신규 모델 정보 및 품질개선 진행사항

엔진사업부
2017/12/15

1.1 80AK1,90DK5,100AK1 모델(1)

● 실린더 헤드

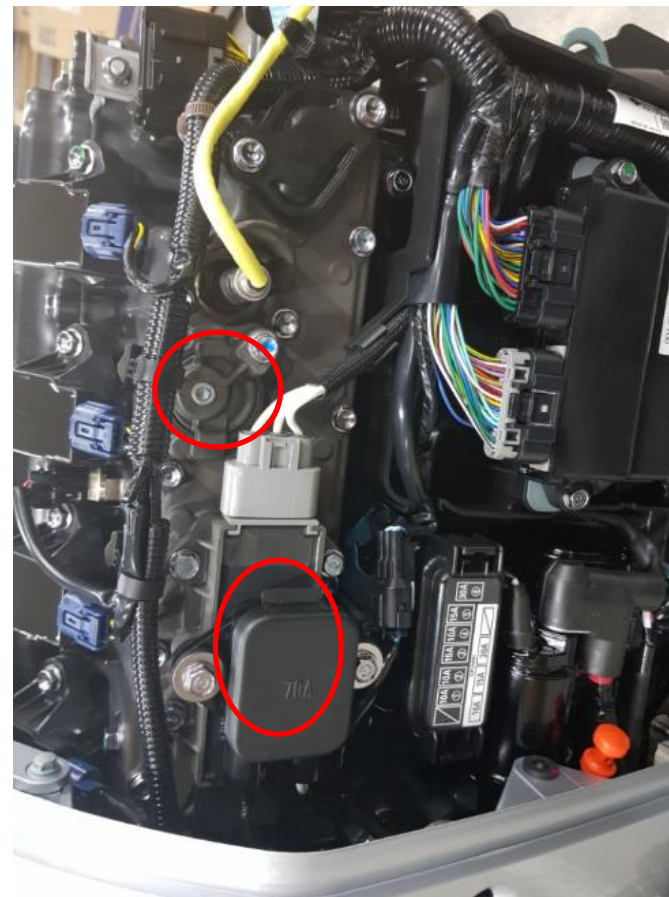
- 실린더 헤드 (아노드 설치 위치 변경)
12210-ZY9-H001 → 12210-ZY9 -M000
- 워터 자켓 커버 (아노드 위치 및 디자인 변경)
19361-ZY9 -0100 → 19361-ZY9 -M000
- 아노드 커버 (새 부품)
- 19380-ZY9-M000

- 실린더 헤드

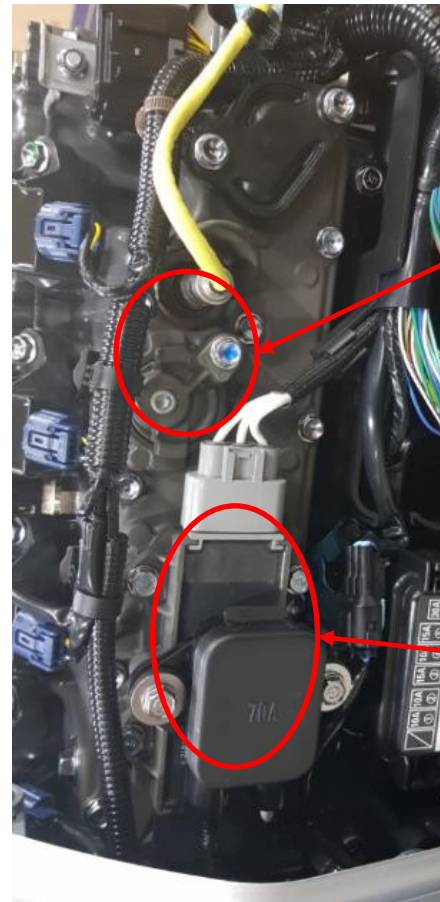
<개선 전>

<개선 후>

● 실린더 블럭

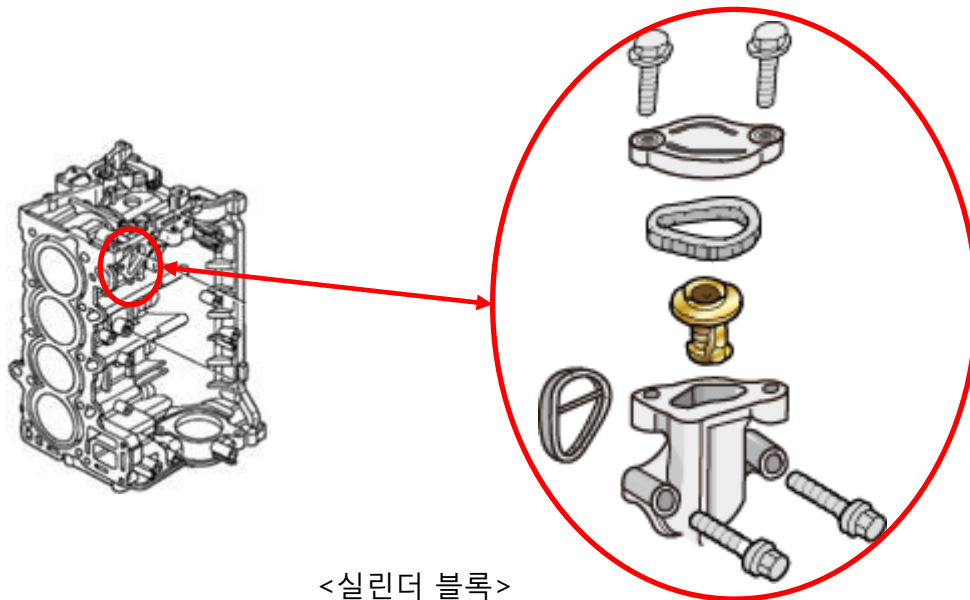
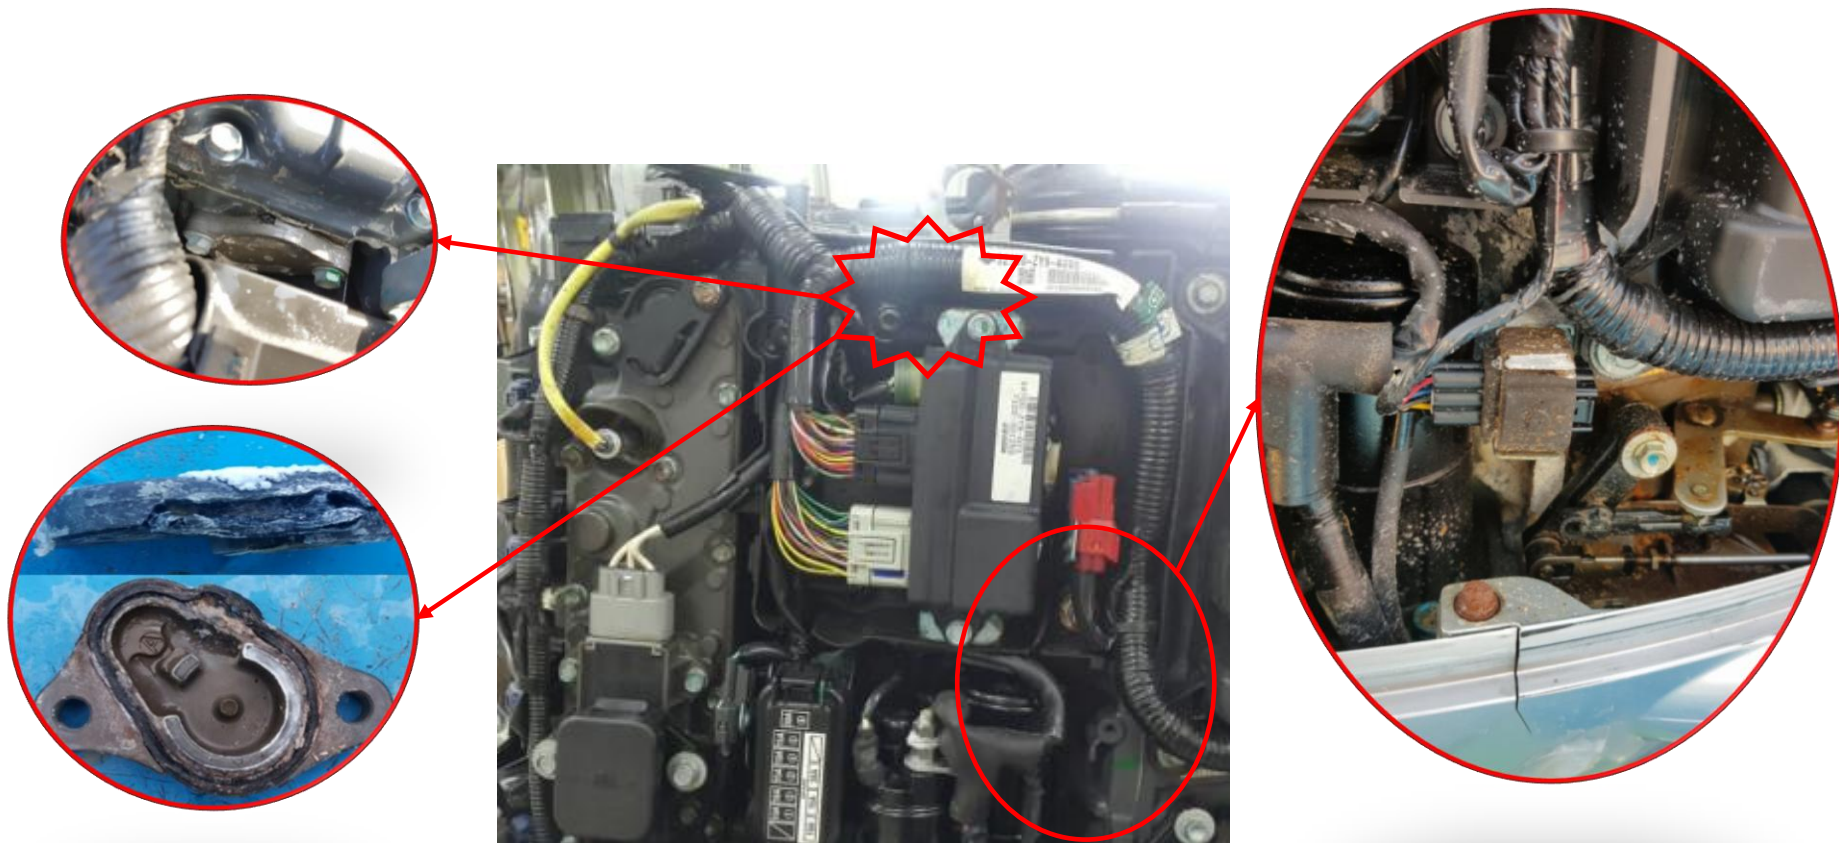
•실린더 블록부분 (써머스탯 장착위치 변경)

슬리브:11102-PWC -3004 → 11102-RB1 -3001

블록:12100-ZY9 -H000 → 12100-ZY9 -M000

•써머스탯 커버부분(써머스탯 장착위치 변경)

써머스탯 커버 :19315-ZY9 -H000 → 19315-ZW9 -0003

써머스탯 케이스: 19330-ZY9 -M000

케이스 패킹 :19331-ZY9 -M000

•발전기 커버

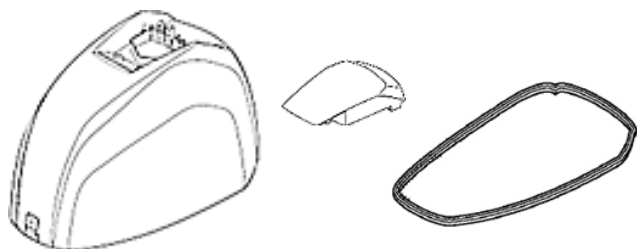
변경된 발전기 커버의 핀 부분은 엔진커버로 물이 새지 않도록 변경.

재질 P.P + talc

31145-ZY9 -0001 → 31145-ZY9 -M000

•엔진커버 (디자인 변경)

63101-ZY9 -3002 → 63101-ZZ0-M000-H1

• 탭 커버

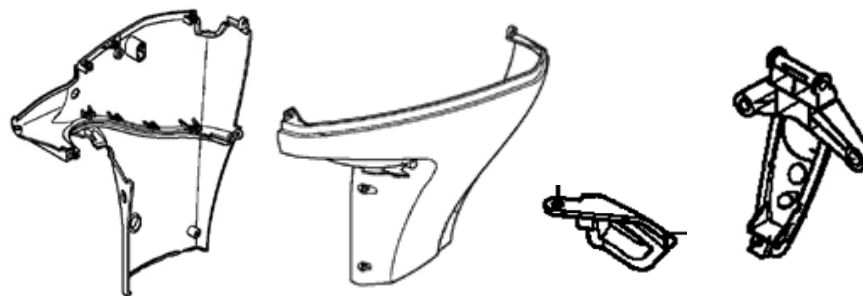
63112-ZY9 -3101 → 63112-ZZ0-M000-H1

• 엔진커버 실링

길이 1855mm → 1872mm

63102-ZY9 -0100 → 63102-ZZ0 -M000

• 언더커버 R

63711-ZY9 -0100 → 63711-ZZ0 -M000

• 언더커버 L

63716-ZY9 -0100 → 63716-ZZ0 -M000

• 플러그 교체 커버

63347-ZY9 -0100 → 63347-ZZ0 -M000

• 리어 언더커버 브라켓

40155-ZY9 -0100 → 40155-ZZ0 -M000

● 워터 자켓 커버

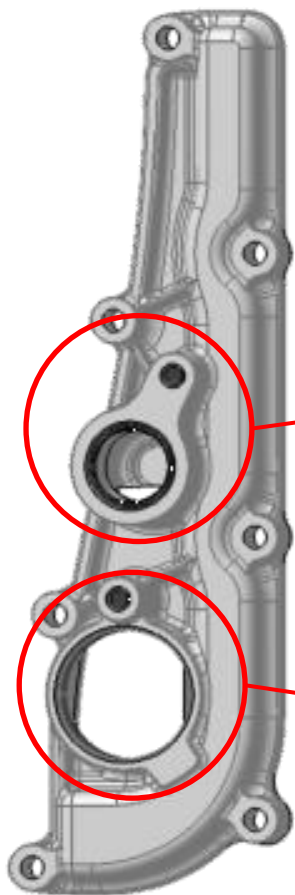
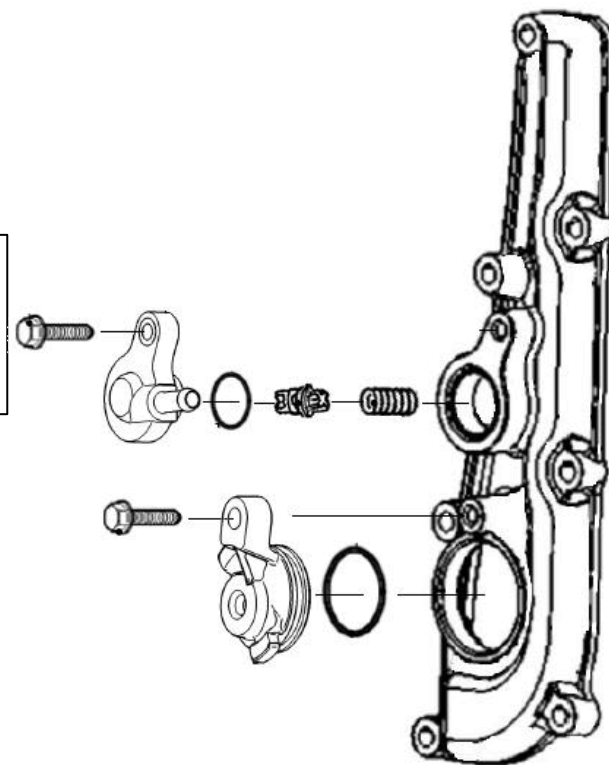
•워터 자켓 커버

2군데 홀 추가 (플러싱 밸브, 아노드 메탈 부)

플러싱 및 아노드 메탈 유지보수 간편화

재질변화 (Silafont36)

19361-ZV5 -0007 →19361-ZZ5-M000

•플러싱 밸브 커버

재질 PA6+GF30

19277-ZZ5 -M000

•안노드 커버

재질 Silafont36

19381-ZZ5-M000

- 공기 유입구

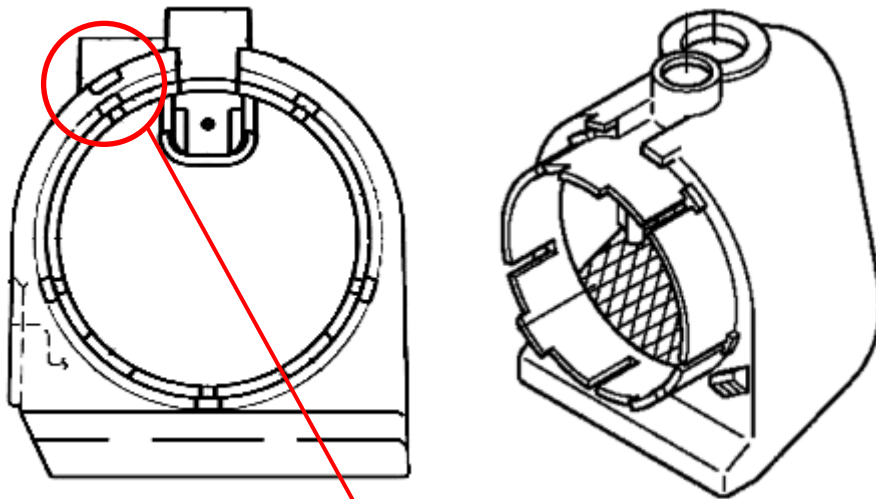
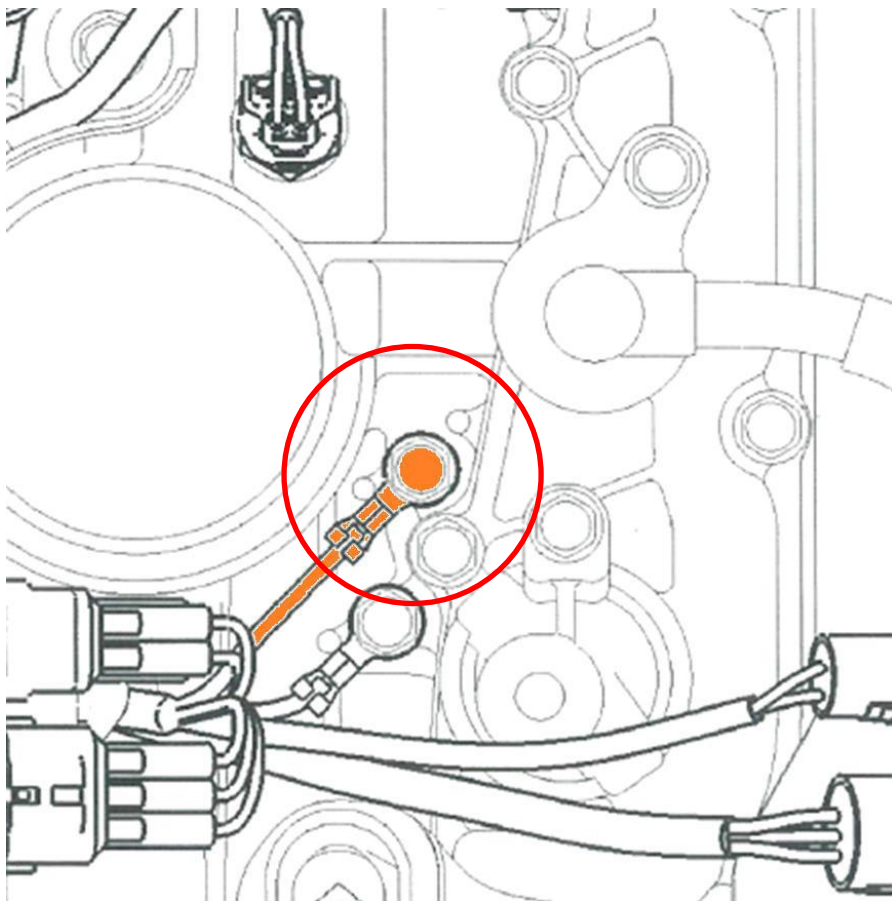
고정 밴드 돌출부 위치 변경

17201-ZZ5 -0101 → 17200-ZZ5 -M000

● 기타

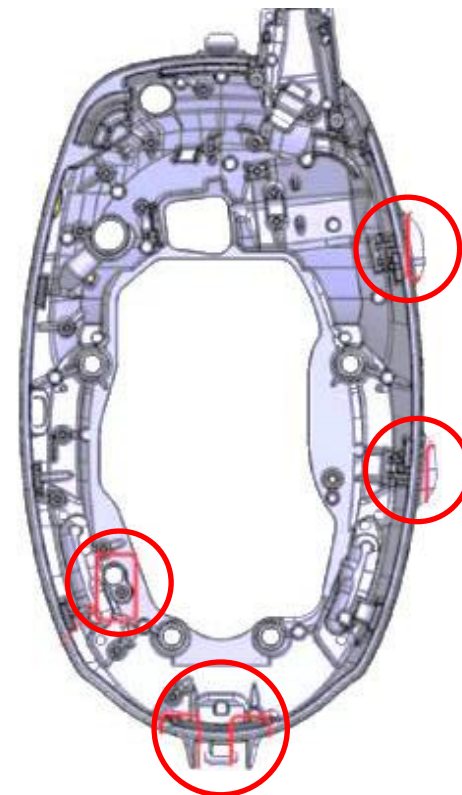
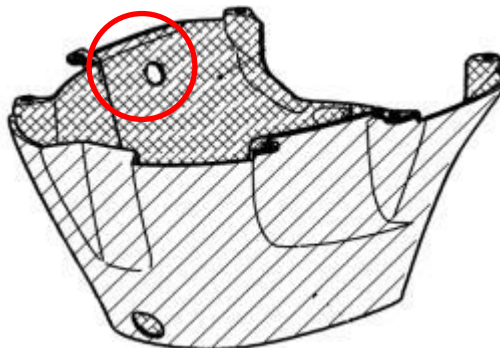
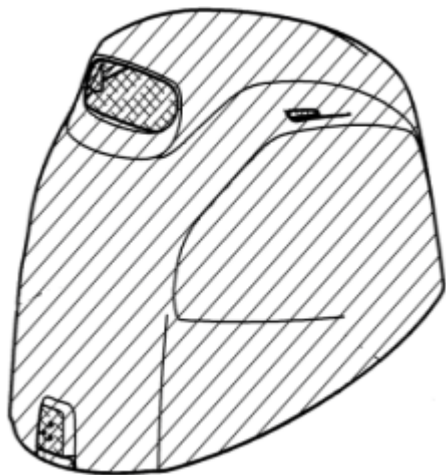
•엔진커버

디자인 변경

63101-ZZ5 -3002 → 63100-ZZ5 -M000

•언더커버

디자인 변경

플러싱 튜브 장착부 추가

63701-ZV5 -0102 → 63701-ZZ5 -M000

•언더케이스

디자인 부분 변경

•워터 조인트 캡 추가

40101-ZZ5 -0004 → 40101-ZZ5 -M000

● 80~100, 115~150HP 체인커버 개선

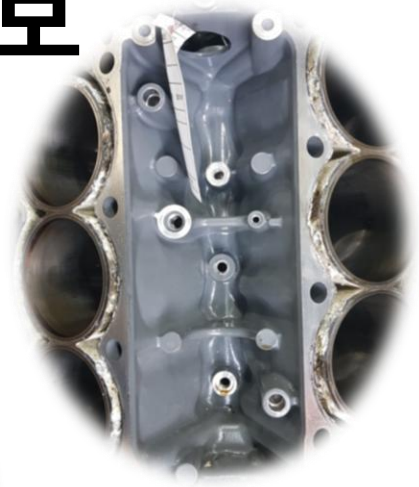
11410-ZY9-415ZA

Groove addition

11410-ZY6-435ZA

● 블록 부식 방지(아노드 연결-SDN 모니터중)

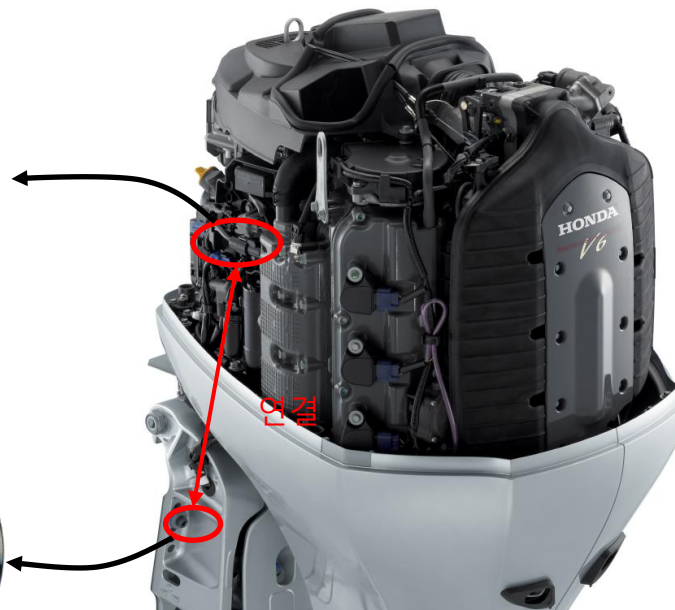
- 블록의 접지 볼트와 스텐브라켓(파워트림 각센서) 연결
- 파워트림 아노드와 브라켓(별도제작)의 아노드 연결

● 115~150HP 서머스텝 커버 냉각수 누수

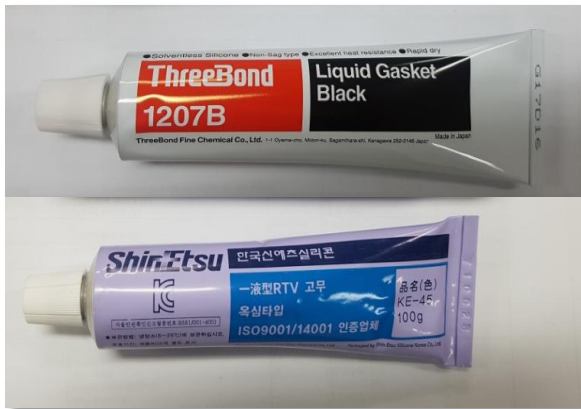
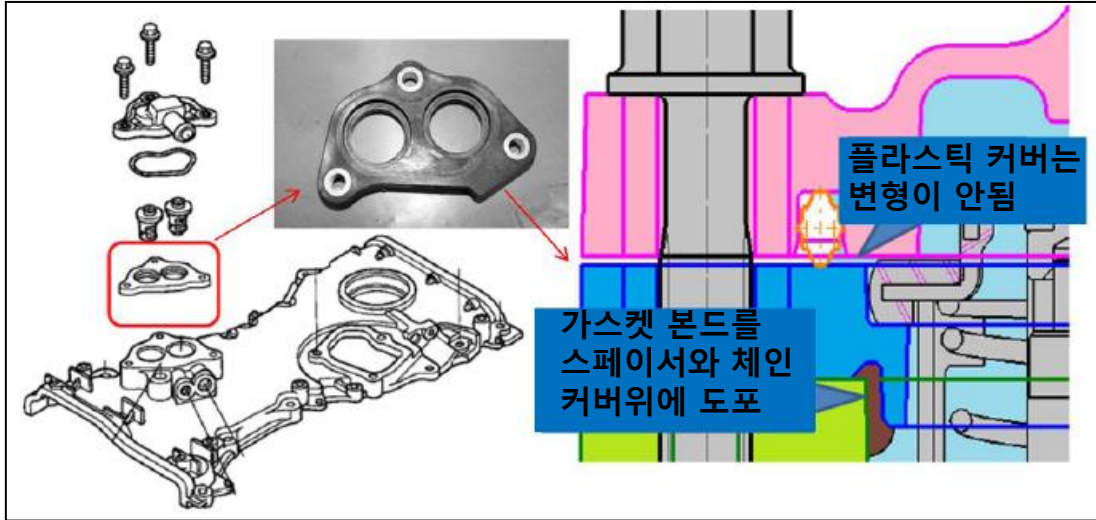
충분한 양을 스페이서 밑면에 도포

*가스켓 본드를 바르기전 스페이서와 체인커버면의 유분기를 완전히 제거 해야함.

*가스켓 본드 도포 후 일정시간이 흐른 뒤 시운전을 해야함(최소 15분정도)
